Addendum No. 1
Page 1 of 3

Project: **GENERAL CONSTRUCTION CONTRACT FOR EARTHWORKS,
UNDERGROUND DEEP & SHALLOW UTILITIES, CONCRETE
CURBS & GUTTERS, ASPHALT PAVEMENT AND LANDSCAPE**

**MICHAEL THOMAS WAY EXTENSION
STEATFORD, PRINCE EDWARD ISLAND**

ADDENDUM #1

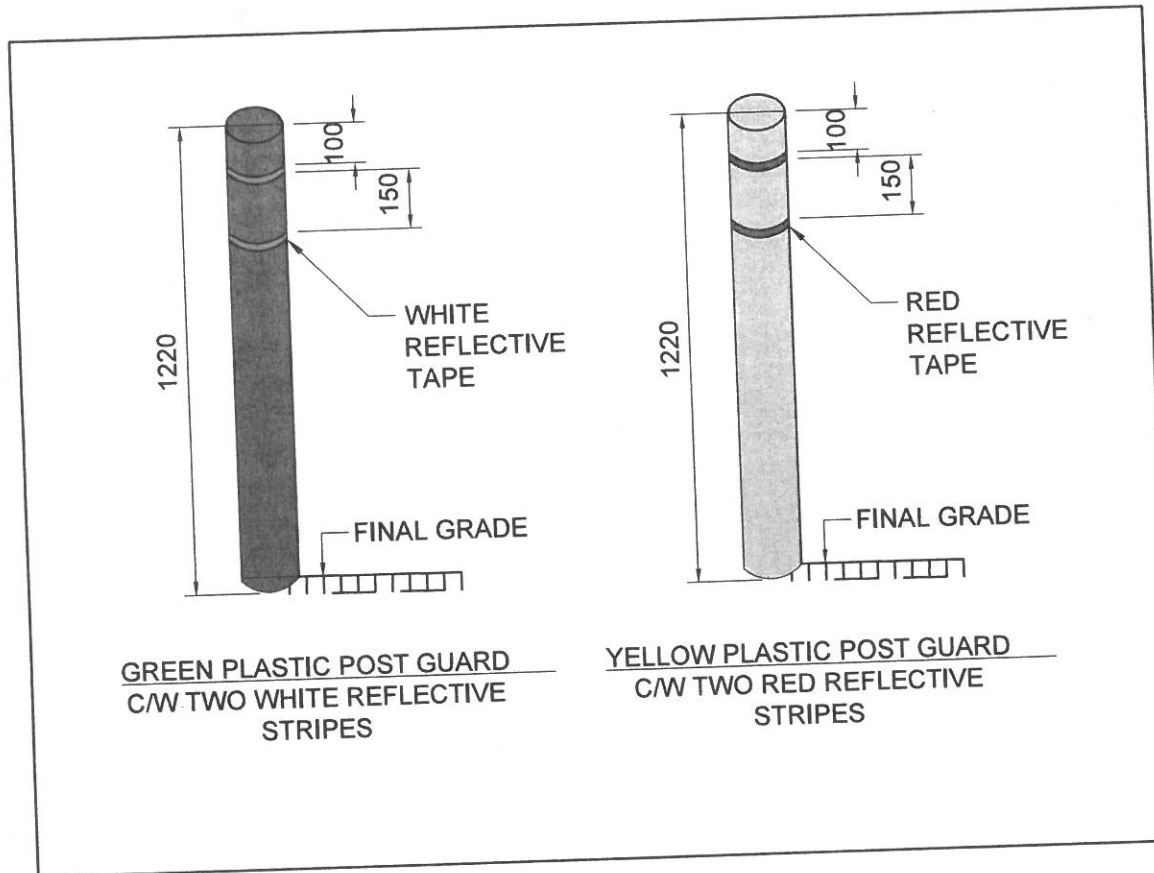
1.2 Bollards to be as shown in attached detail.
